RE: Notice to Bidders
Great Rivers Greenway District
Centennial Greenway Phase IIA
Federal Project Number: TAP-9900(677)
Burns & McDonnell Project Number: 85395
Addendum Number 02

CENTENNIAL GREENWAY – PHASE IIA

ADD ALTERNATES 1 THROUGH 3 CLARIFICATION

project 85395	contract
drawing C-102	rev. 0

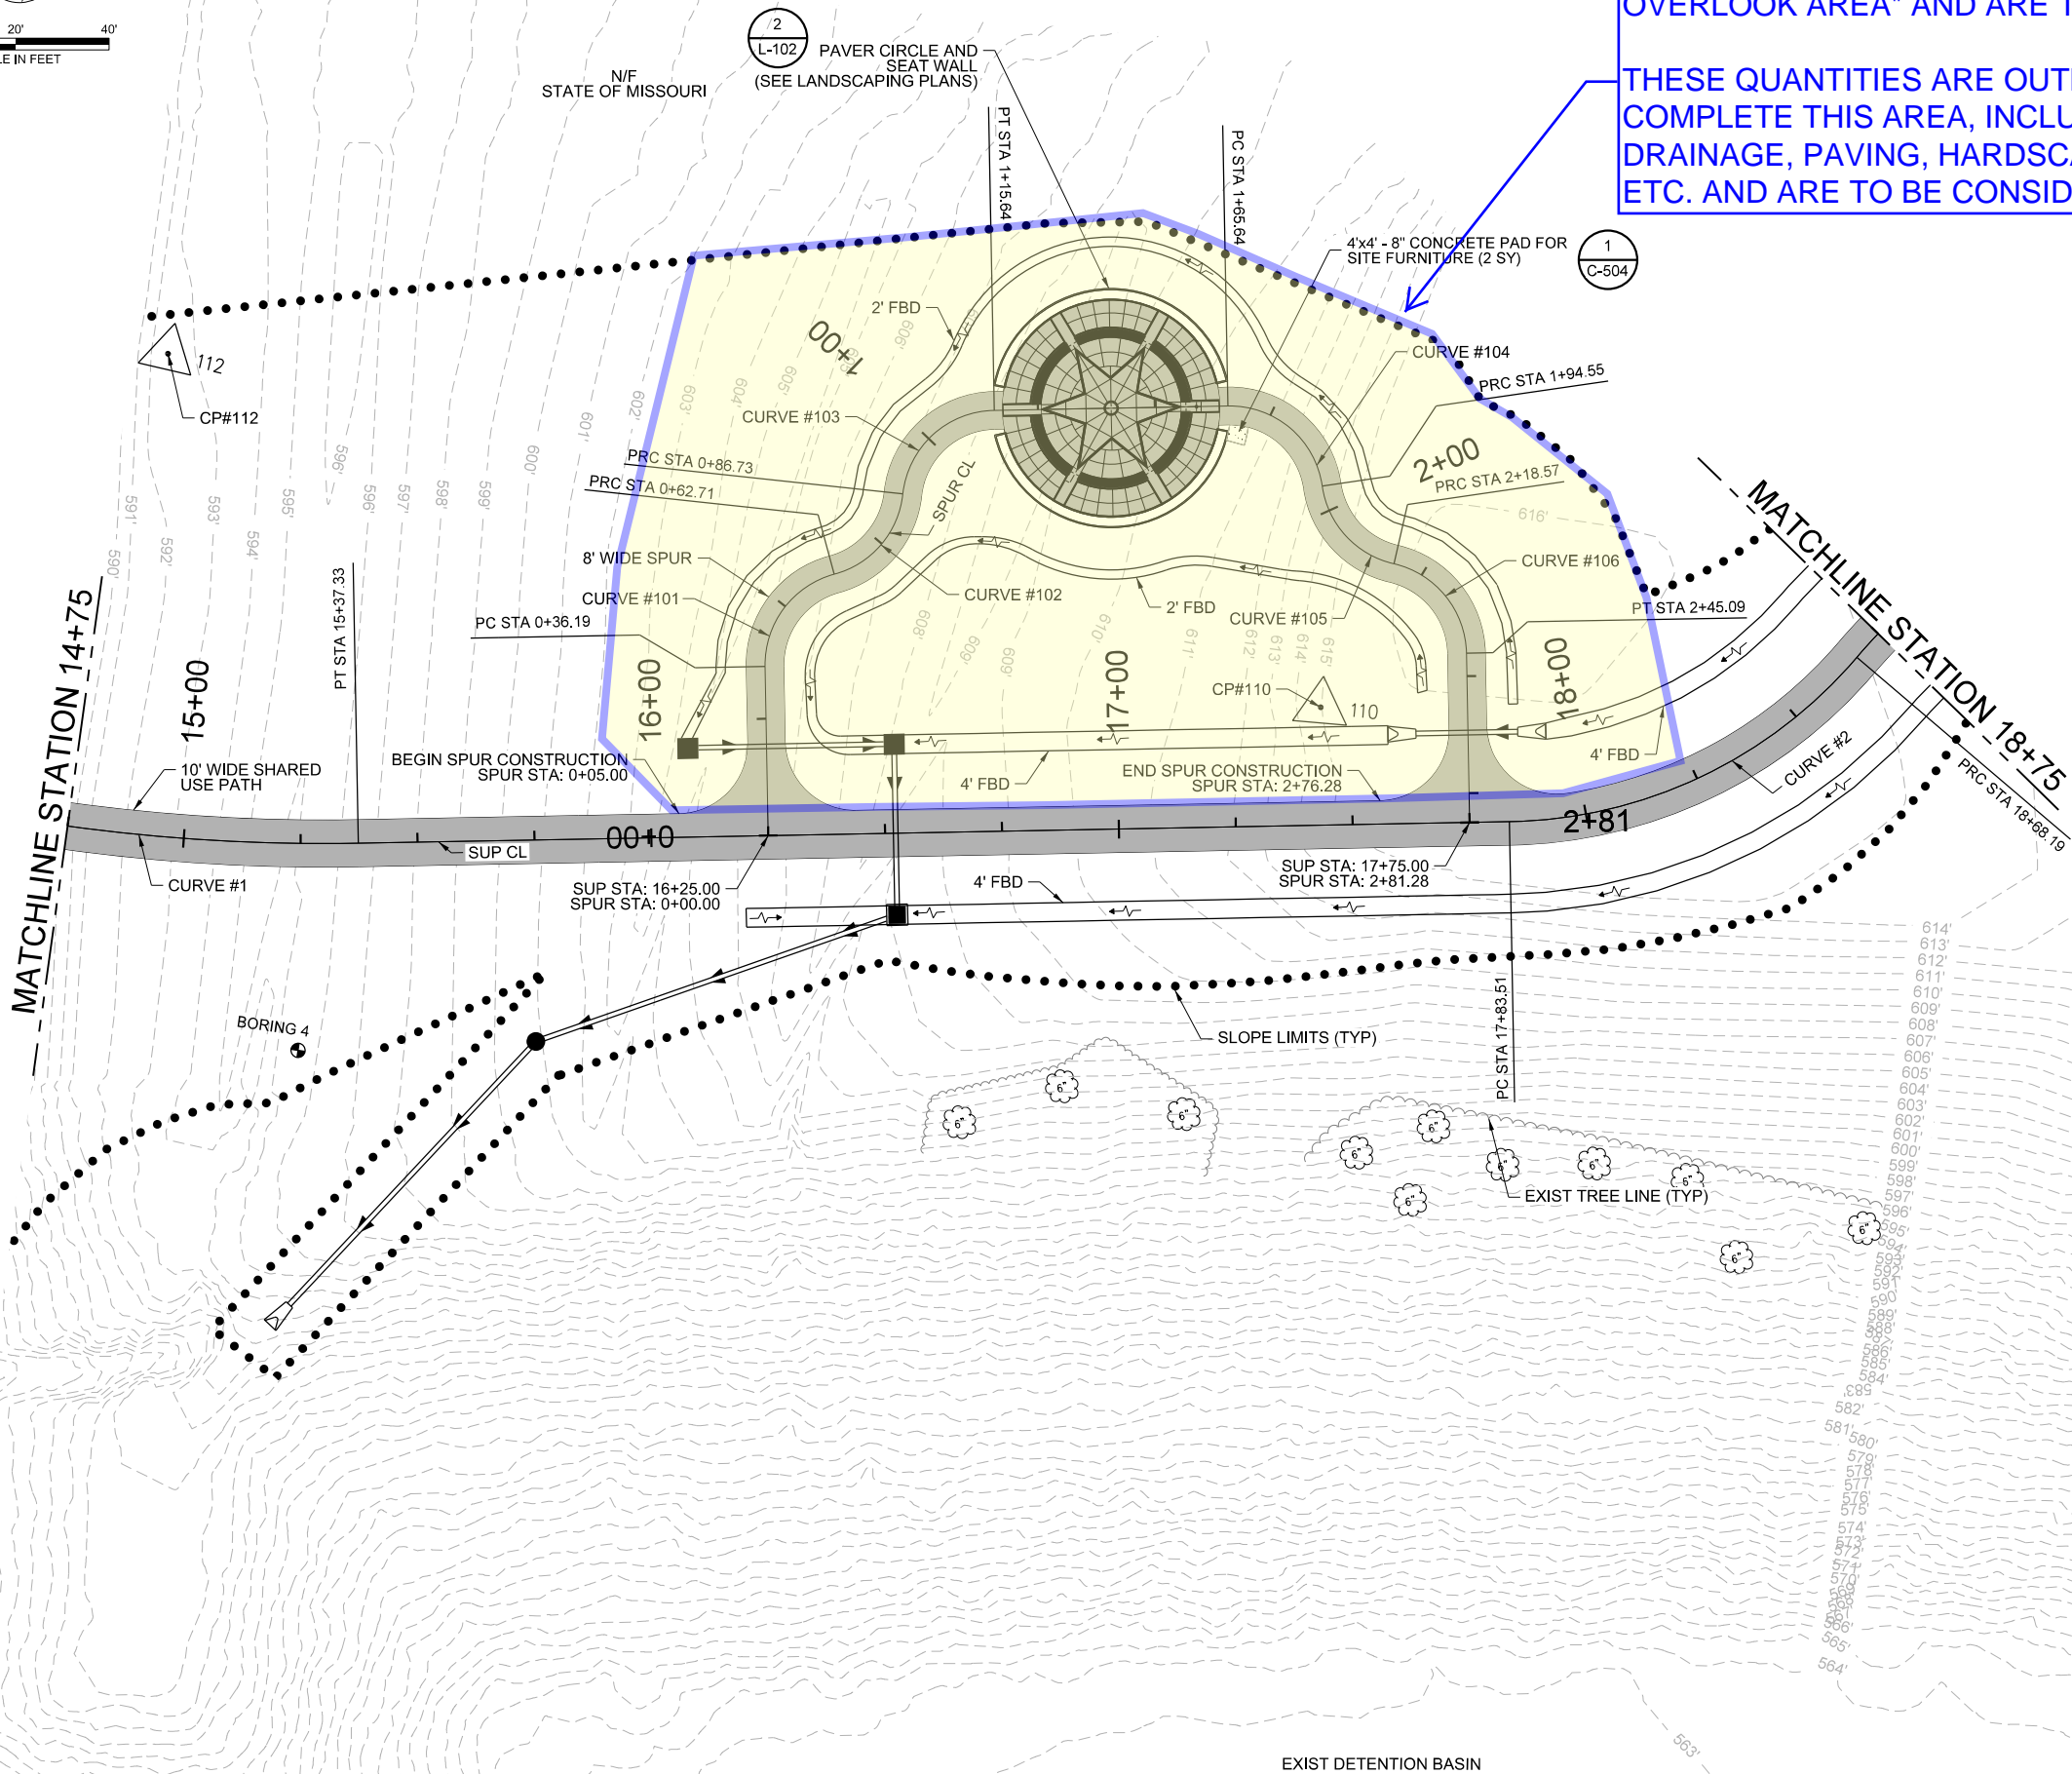
ALL ITEMS IN THIS SHAPE ARE SPECIFICALLY FOR THE "SPUR AND OVERLOOK AREA" AND ARE TO BE CONSIDERED ADD ALT 2.

THESE QUANTITIES ARE OUTLINED ON SHEET 2B-5. ALL ITEMS NEEDED TO COMPLETE THIS AREA, INCLUDING BUT NOT LIMITED TO, ARE GRADING, DRAINAGE, PAVING, HARDSCAPING, LANDSCAPING, EROSION CONTROL, ETC. AND ARE TO BE CONSIDERED INCLUDED IN ADD ALT 2.
